Energy Corridor Programmatic EIS Scoping Comment: 80079

Re: Bonneville Power Administration Comments on Notice of Intent to Prepare
Programmatic Environmental Impact Statement, 70 Federal Register 56647
(Sept. 28, 2005)

Potential BPA Transmission Line Corridors

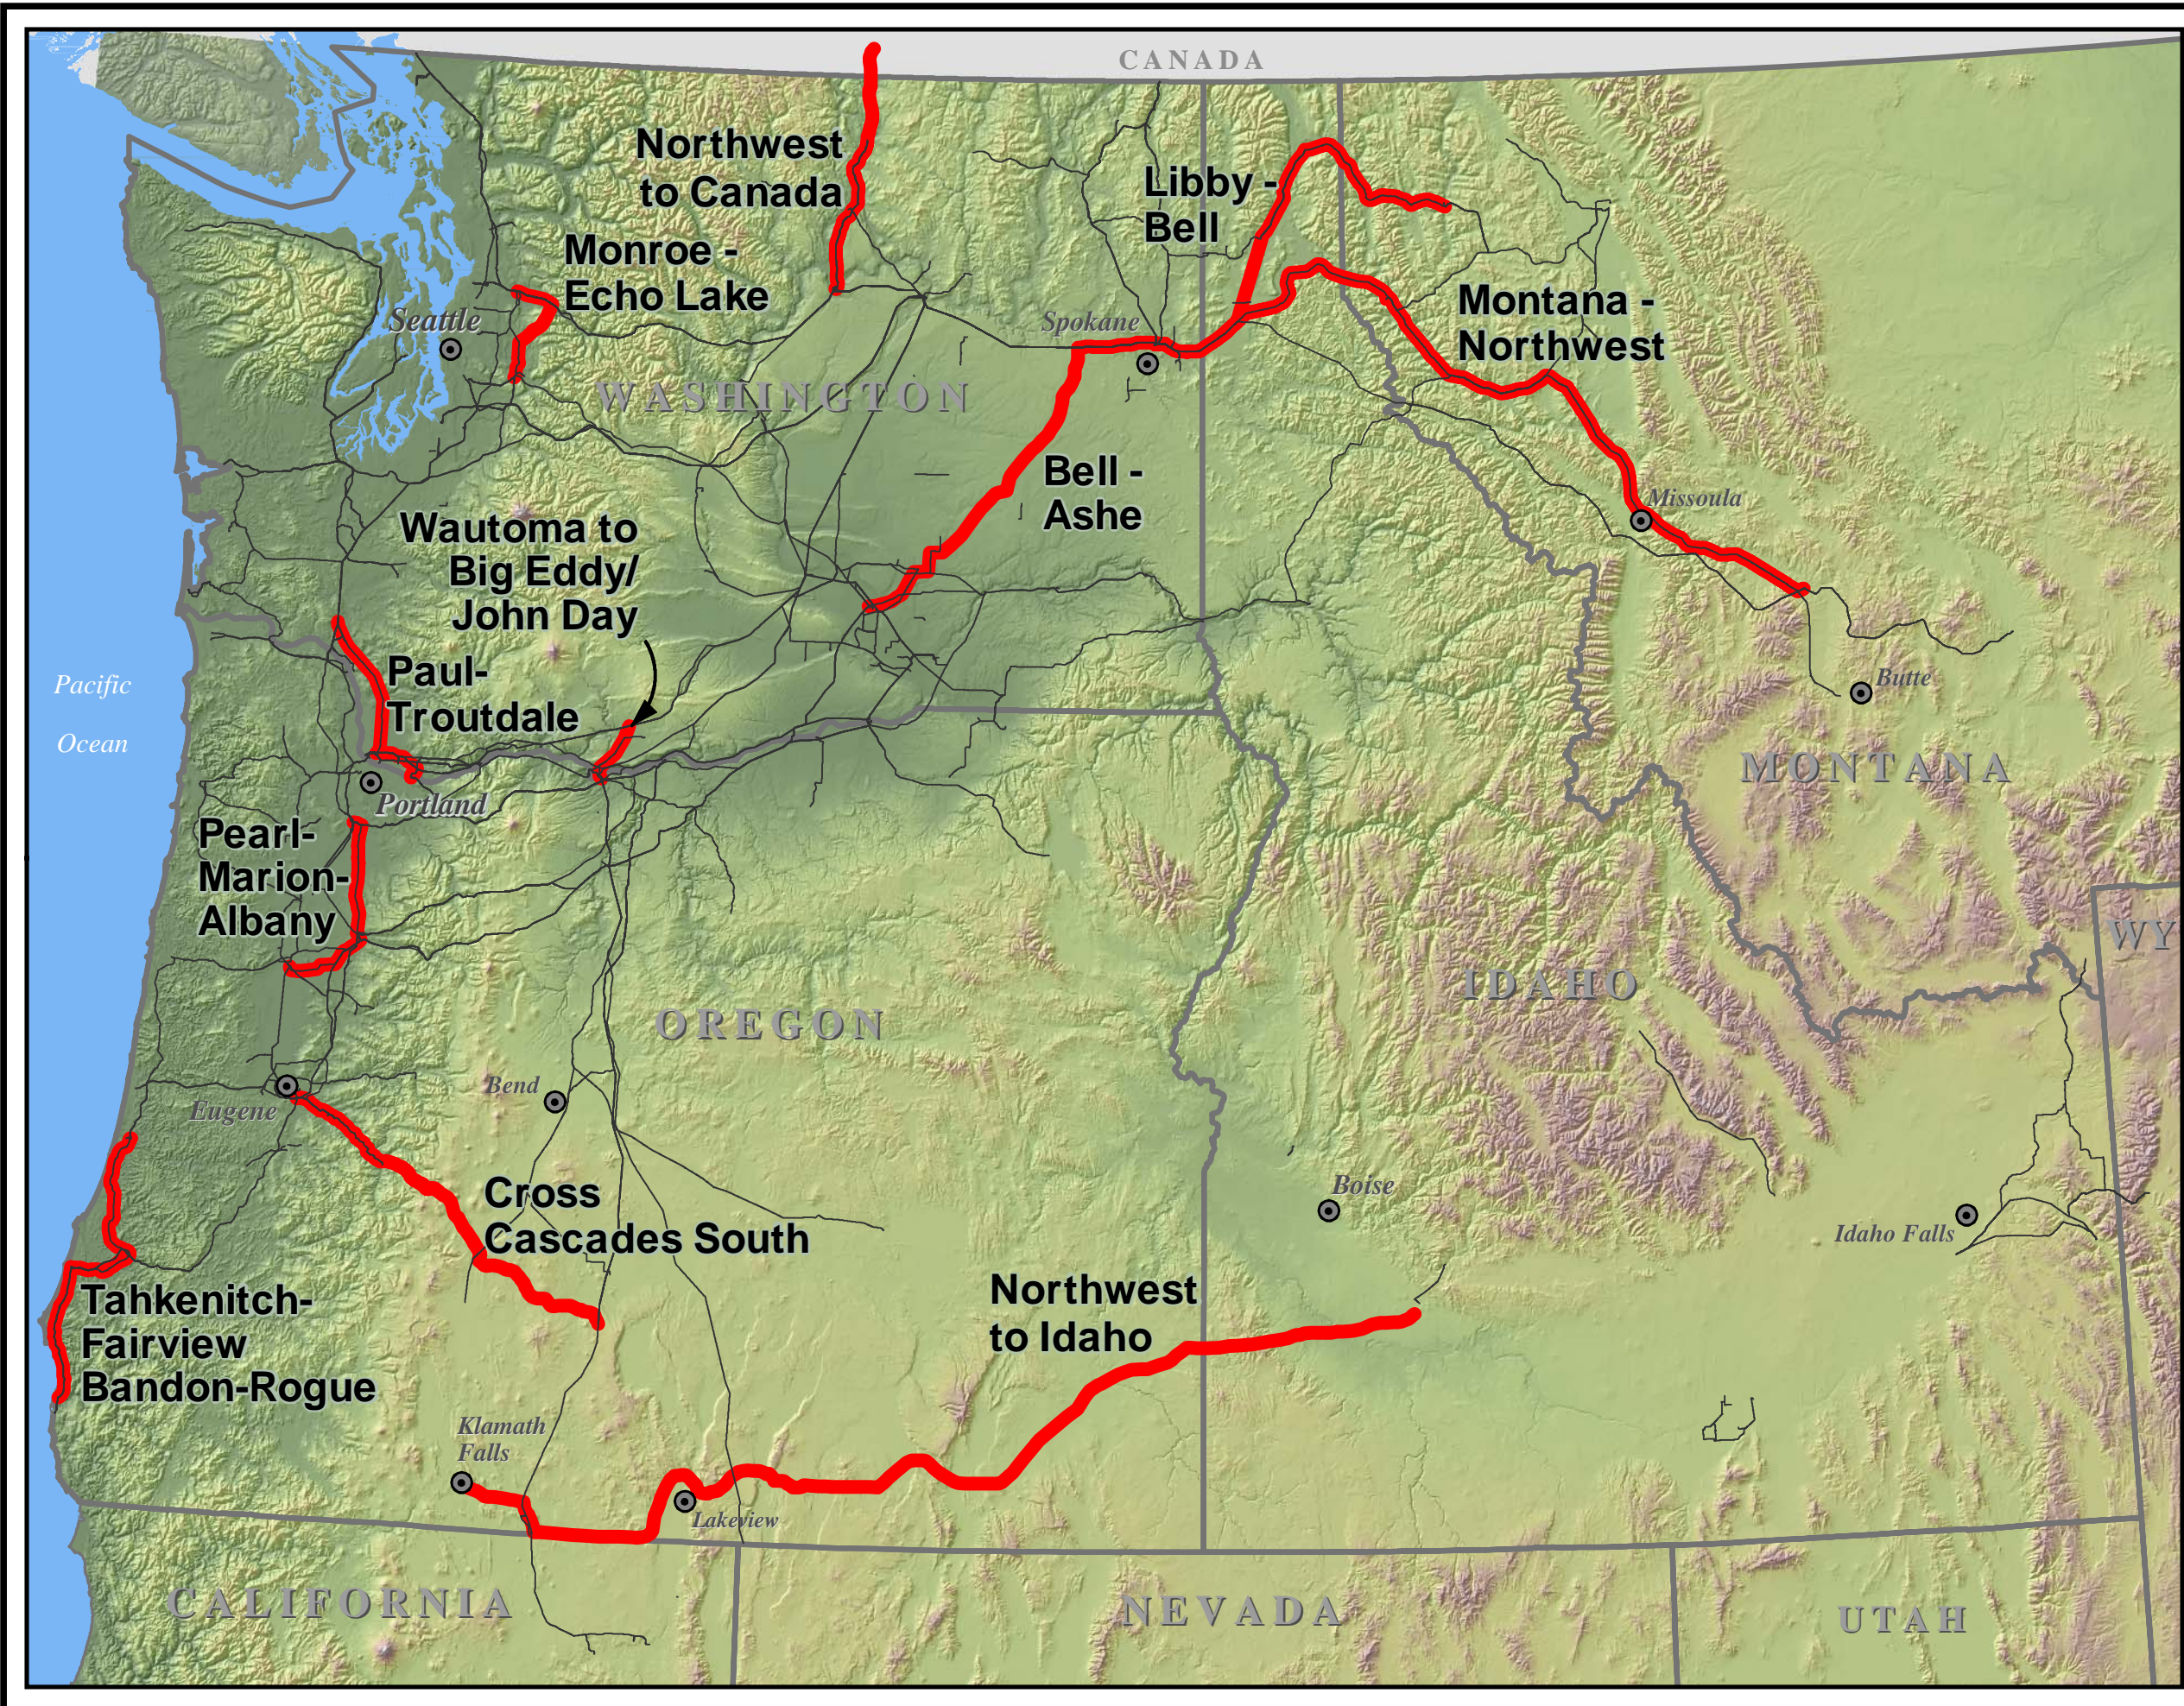
Our potential corridor needs are summarized as follows. We are also attaching a map to help describe these corridors.

1. Paul-Troutdale

The anticipated route is a new corridor from Centralia, Washington south to Vancouver, then east to Camas and south to Troutdale, Oregon.

2. Bell-Ashe

There are some existing ROWs that could partially accommodate a proposed Bell-Ashe line but a direct route between these stations on a new corridor might be needed.

3. Monroe-Echo Lake

Due to reliability concerns and suburban growth in the area, new corridors to the east of the existing corridor will need to be explored.

4. Northwest to Canada

To address parallel reliability concerns, the corridor between Coulee/Chief Joe and Oliver, British Columbia (Vaseux Lake Substation) needs to be explored.

5. Northwest to Idaho

Options to add capacity to this path may include expanding the existing WECC Path 18 from Montana into Idaho or a new line from McNary to Brownlee (and farther into Idaho). A new corridor from Klamath Falls, Oregon through Lakeview and Fields into Idaho should also be considered.

6. Montana-Northwest

Options to add capacity to this path may include the existing Garrison-Hot Springs-Bell ROW or upgrades to the existing Path 18 from Montana into Idaho. Upgrades to the latter path would also require additions to the Northwest to Idaho path as mentioned above.

7. Wautoma to Big Eddy/John Day

Options to add capacity to this path may include several existing ROWs or a new corridor.

8. Cross Cascades South

Options to add capacity to this path may include several existing ROWs or a new Summer Lake-Alvey corridor could be developed.

9. Tahkenitch-Fairview, Bandon-Rogue

Options to add capacity to this path may include several existing ROWs or a new corridor developed in the vicinity.

10. Pearl-Marion-Albany

This path need can probably be accommodated using existing ROWs although a new corridor might be required.

11. Libby-Bell

Options to add capacity to this path may include existing ROWs or a new corridor in the vicinity of the existing one could be developed.
